Access Compliance Report

Public Rights-of-Way

Intersection ID: 12766	Main Street: S_GRAHAM_ST	Cross Street: W_PALMER_ST	Location: W
ADA ID: 97FA11AB0AA3	Ramp Type: PerpDiag	Initial Pass/Fail: Fail	Overall Compliance: No
		Severity Score: 12.5

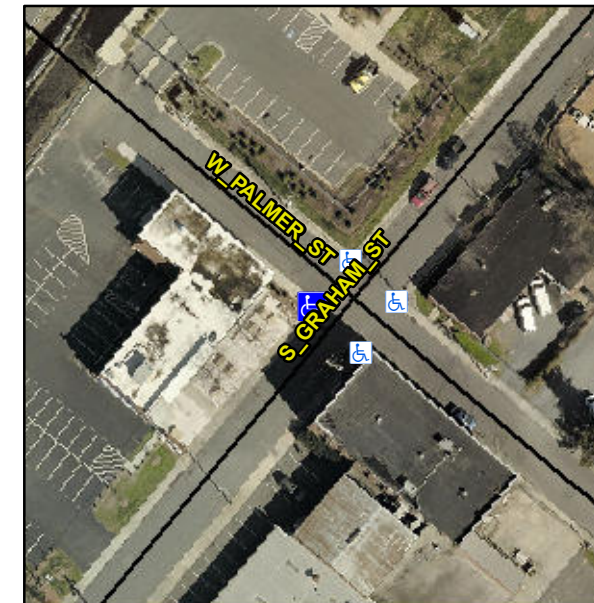
Not Found, R304.5.3

Compliance	Description	Data	Compliance	Description	Data
N/A	Ramp Length (in)	56.0	Yes	Ramp Slope (%)	8.0
Yes	Ramp Width (in)	48.0	No	Ramp XSlope (%)	6.5
N/A	Flare Type LT	N/A	N/A	Flare Type RT	N/A
N/A	Flare Slope LT (%)	N/A	N/A	Flare Slope RT (%)	N/A
N/A	Flare Traversable LT?	N/A	N/A	Flare Traversable RT?	N/A
N/A	Landing Length (in)	N/A	N/A	DWS Provided?	N/A
N/A	Landing Width (in)	N/A	N/A	DWS Contrast?	N/A
N/A	Landing Slope (%)	N/A	N/A	DWS Length (in)	N/A
N/A	Landing X Slope (%)	N/A	N/A	DWS Full Width?	N/A
N/A	Landing Curb? (Y/N)	N/A	N/A	DWS Offset (in)	N/A
N/A	Shared Landing?	N/A			
N/A	Gutter Ponding?	N/A	N/A	Gutter Slope (%)	N/A
N/A	Gutter Lip Ht (in)	N/A	N/A	Gutter X Slope (%)	N/A
N/A	Painted X Walk1?	No	N/A	Painted X Walk2?	No
	X Walk 1 Direction	To SE		X Walk 2 Direction	To NE
N/A	X Walk 1 Width (in)	N/A	N/A	X Walk 2 Width (in)	N/A
	X Walk 1 Slope (%)	4.9		X Walk 2 Slope (%)	0.3
	X Walk 1 X Slope (%)	1.5		X Walk 2 X Slope (%)	5.1

Remove & Replace Curb Ramp With Two New Directional Ramps or Equivalent.
